APPARATUS AFFECTED: 37 Electrical Service Units (YESU) part of 37 ASR, RO and ROTR Teletypewriter Sets used in Multipoint Private Line Service.
TP332541 Circuit Card Set (RO).
TP332549 Circuit Card Set (RO).
TP332587 Circuit Card Set (ROTR).
TP332642 Circuit Card Set (ASR).
TP332658 Circuit Card Set (ASR).
See NOTE in CHANGE.

PART AFFECTED: TP322308 Multipoint Private Line Channel Control Circuit Card Assembly (MC308).

REASON FOR REISSUE: To change Appendix number and to correct SUPPLEMENTAL INFORMATION.

**TP322308 MULTIPPOINT PRIVATE LINE CHANNEL CONTROL CIRCUIT
CARD ASSEMBLY**

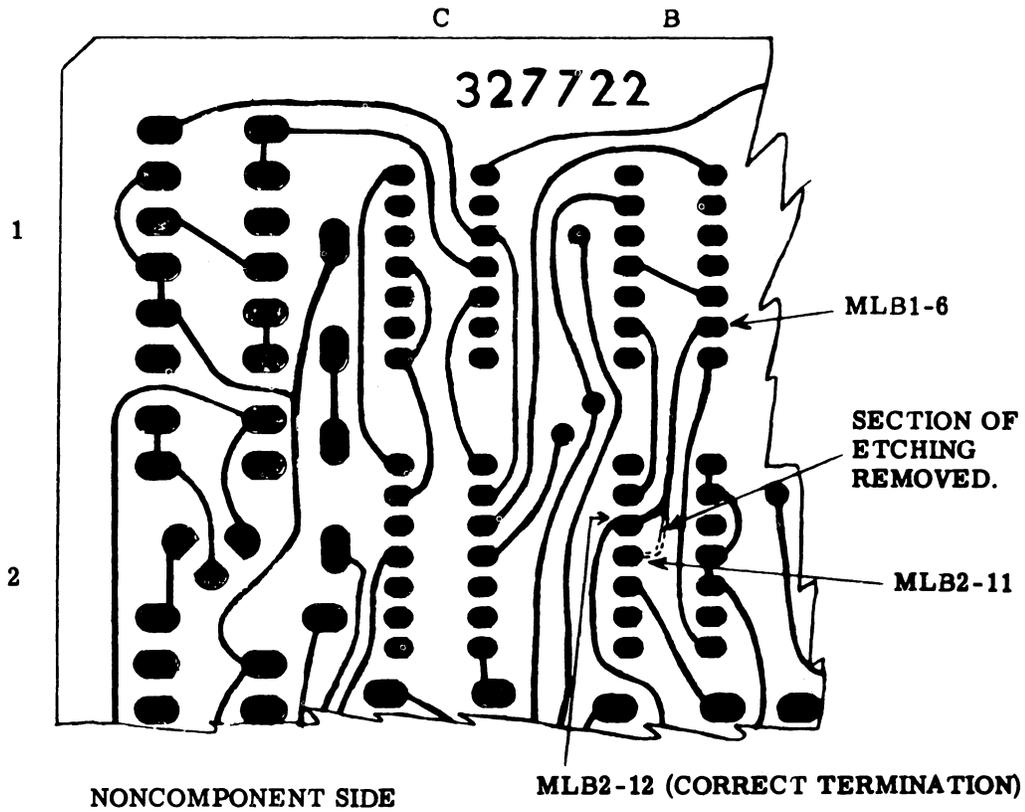
CHANGE: On the etched circuit board of the TP322308 circuit card assembly (noncomponent side), the etched circuit path between MLB1-6 and MLB2-11 is removed and an etched circuit path between MLB1-6 and MLB2-12 is added.

NOTE: This change only affects some TP322308 circuit card assemblies that were manufactured with a connection between MLB1-6 and MLB2-11 instead of between MLB1-6 and MLB2-12; however, all TP322308 circuit card assemblies should be checked to determine whether or not modification per Attachment Sheet 1 is required.

**MODIFICATION OF TP322308 CIRCUIT CARD ASSEMBLY THAT HAS
MLB1-6 CONNECTED TO MLB2-11 INSTEAD OF TO MLB2-12:**

**REMOVE SECTION OF ETCHING AT MLB2-11 (SHOWN DOTTED)
AND CONNECT ETCHED CIRCUIT PATH (FROM MLB1-6) TO
MLB2-12, AS SHOWN.**
